WCAP- 10987
Addendum 1

RE-ANALYSIS OF WATTS BAR AND CATAWBA
CONTAINMENT TEMPERATURES IN RESPONSE TO
LANL EVALUATION OF LOTIC-III HEAT TRANSFER MODELS

AUGUST, 1988

Figure II-1 Correction Factor, T , vs. Gas Velocity, U_g

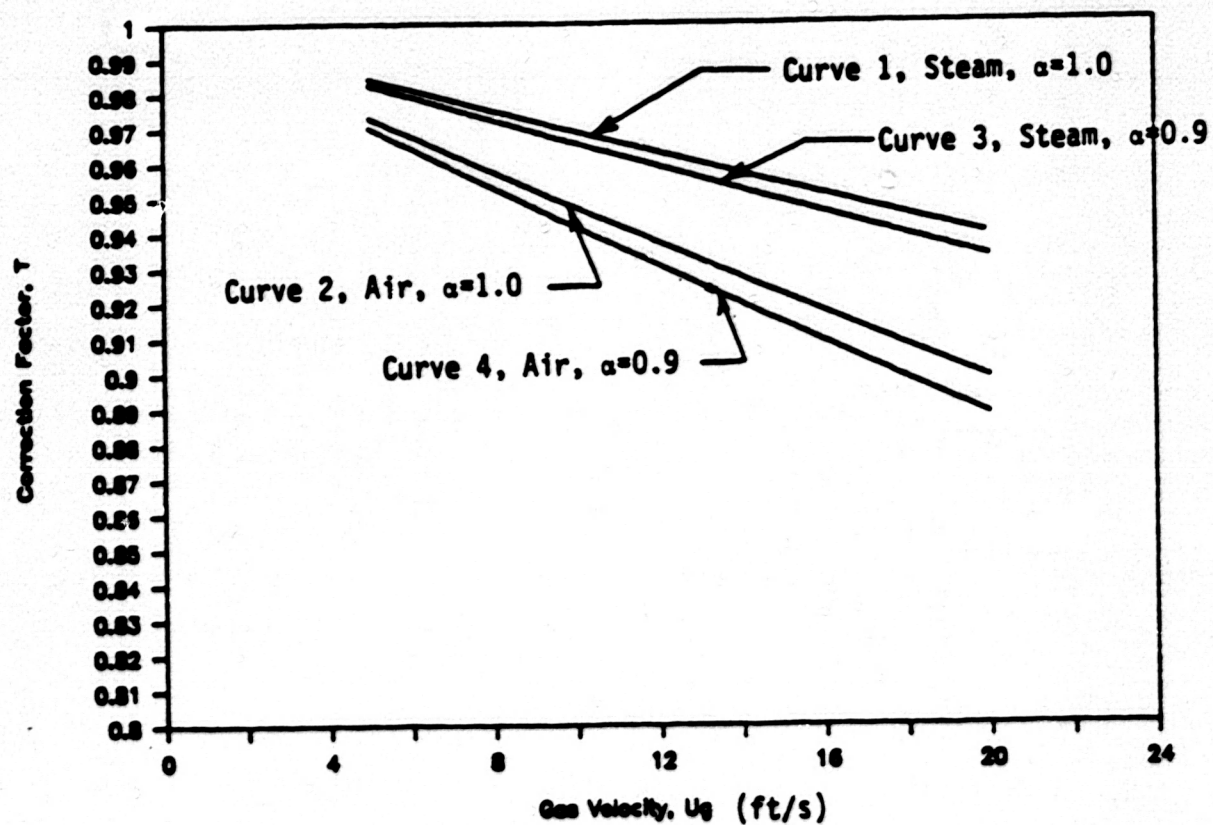
Curves 1 and 2 in Figure II-1 show the correction factor, T , v.s. u_g without the correction of α mentioned earlier. For both air and steam, T is decreasing with increasing u_g . This is reasonable since higher u_g leads to better heat transfer between the droplet and the surrounding air/steam, hence lower air/steam temperature.

Curves 3 and 4 in Figure II-1 show the correction factor, T , v.s. u_g with the correction of α for steam and air, respectively. The value of α used in these calculations is 0.9. It is found that with α included, T is smaller.

The derivation of the correction factor described in the Appendix D of Reference 2 is reviewed. With given assumptions and considerations in the derivation of the correction factor, it is the reviewer's opinion that the correction factor is appropriate for the stated purpose. A value of $T=0.96$ is used for steam case as suggested by Reference 2.
